Lockyer Valley Regional Council: Inland Rail EIS Review – Helidon to Calvert (H2C)

| # | EIS section and topic | Comment <i>What is the issue or what is suitable within the EIS</i> | Recommendation <i>What changes to the EIS or additional information is required?</i> |

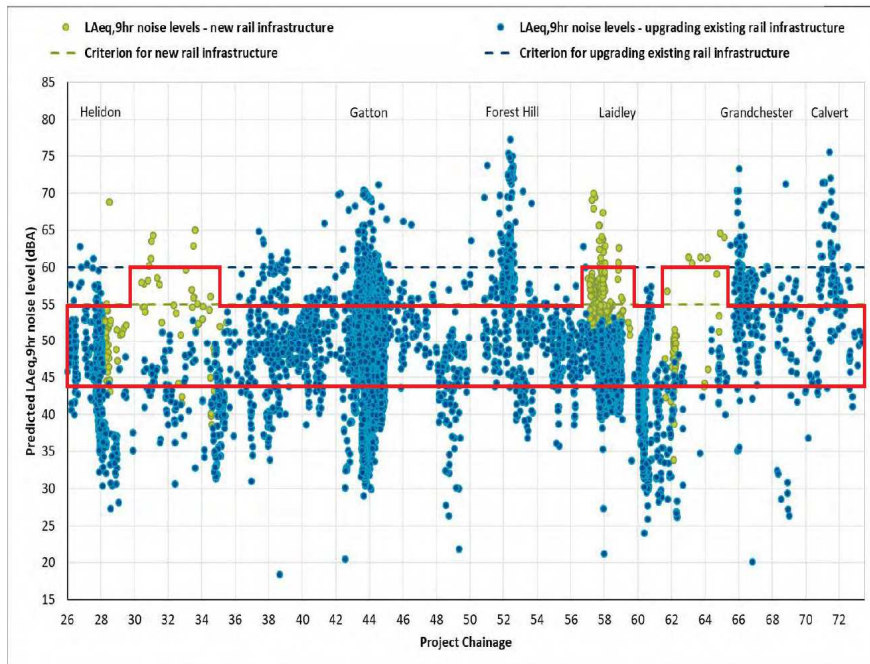
| 109 | Chapter 15 Section 15.8.8.7 (Assessment of Sleep Disturbance) Appendix P, Figure 24 | <p>Thousands of adversely affected properties not considered – Section 15.8.8 also states that ‘this guidance acknowledges the establishment of relationships between single event noise indicators, such as L_{Amax}, and long-term health outcomes remains tentative’. The draft EIS did not utilise the most current authoritative guidance on the topic of sleep disturbance. The WHO released new guidelines in 2018 which strongly recommend a night time outdoor noise limit of 44 dBA Leq,night (external façade level) for noise from a railway. The draft EIS does not reference this current document.</p> <p>The proponent has adopted trigger levels of 55 dBA Leq,night and 80dBA L_{max}, both of which appear to have no connection to any credible guidance on the mitigation of sleep disturbance.</p> <p>As it stands, there appear to be <i>over 4000</i> sensitive receptors with predicted night time noise levels of ≥ 44 dB(A) Leq,night but below the criteria adopted by the noise assessment. These <i>4000+ dwellings</i> are not triggered for mitigation but are well above the WHO guidelines for sleep disturbance. The result is that the financial and personal cost of the rail noise impacts are borne by those residents without any form</p> | <p>The draft EIS suggests that 175 properties may experience noise that causes sleep disturbance, however this a grossly misleading and inaccurate claim. The number of houses where sleep disturbance may be experience will be well above 4000 dwellings. The WHO (2018) states that sleeping satisfies a basic need and the absence of undisturbed sleep can have serious effects on human health.</p> <p>The draft EIS requires update to accurately assess the noise impacts of the project, appropriately identify adversely affected sensitive receptors, meet the requirements of the COG’s TOR and demonstrate how the assessment criteria that is currently adopted can possibly protect the ability to sleep at sensitive dwellings. If this cannot be demonstrated, the criteria and assessment need to be revised and the noise assessment undertaken again with the adoption of more appropriate and justifiable criteria for sleep disturbance.</p> |

compensation. See the example figure below (Figure 24 from Appendix P), the red box encloses the dwellings that exceed WHO noise guidelines but do not trigger the proponent's mitigation process.

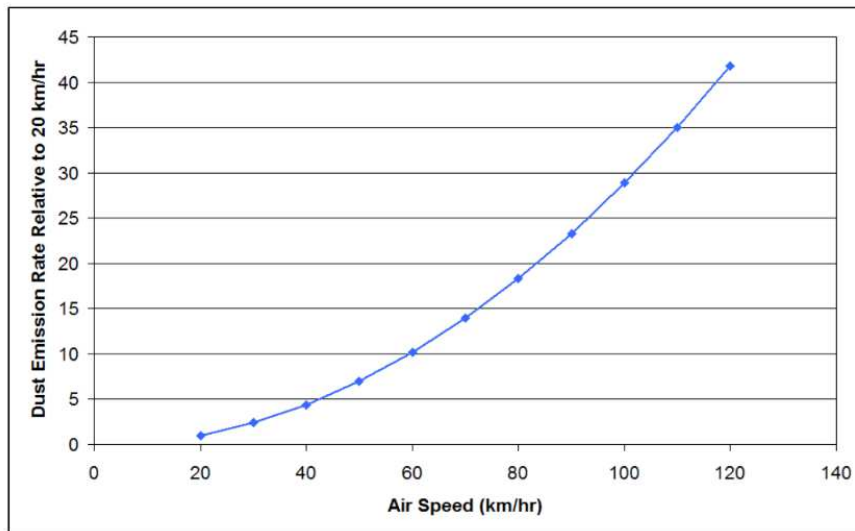
| <p>187</p> | <p>Appendix K (Air Quality)</p> | <p>Coal Dust – Table 2.3, Section 2.3 states that the modelled coal trains were 990 m long, however the project description says trains may be up to 3.6 km long. It is not clear if coal trains will be limited to 990 m or if they may be longer (i.e., up to 1.8 km or 3.6 km long). Table 6.2 in Chapter 6 suggests longer trains could be used based on customer requirements within the maximum train length which is potentially up to 3.6km. The draft EIS does not consider the effect of train lengths up to 3.6 km on air quality from coal dust emissions.</p> <p>Table 4.17, Section 4.4.3.1 describes the release height above ground level of 3.3 to 4.3 m, however the project description clearly states trains will be double stacked and exceed heights of 7 m. We have assumed though it is not stated that coal trains will be limited to single wagons not double stacked. If that is incorrect, the draft EIS does not consider the effect of double stacked train heights on air quality from coal dust emissions.</p> <p>Appendix K and Table 6.2 in Chapter 6 suggest that the maximum coal train speed will be 80 km/hr based on 25 ton axle loads (TAL). The modelling however did seem to include contributions to the effective wind speed over the coal wagons by local winds which could contribute to coal lift off. The Environmental Evaluation of Coal Dust Emissions (Connell Hatch, 2008) suggests that on average, local wind could add 10-15 km/hr to the air speed across the coal surface in the wagon. The graph below is from Environmental Evaluation of Coal Dust Emissions (Connell Hatch, 2008) (which is referred to by the draft EIS). It shows that if air speed across the surface of the coal increased from 80 km/hr to 95 km/hr (assuming an allowance for local winds) the coal dust emission rate would increase by about 35%.</p> | <p>The assessment of coal dust emissions does not meet 11.135 of the TOR because the assessment does not accurately estimate the rate of coal dust lift off and concentration at sensitive receptors. It is recommended that the COG require the proponent to update the air quality impact assessment to include the following to better estimate the potential impact of coal dust emissions at sensitive receptors:</p> <ul style="list-style-type: none"> - Clarify the limit of rollingstock sizes - Assess impacts for all train sizes potentially used - Consider train speeds of 80 km/hr with an appropriate allowance for local winds on coal dust lift off. - Consider train speeds of 115 km/h with an appropriate allowance for local winds on coal dust lift off. |
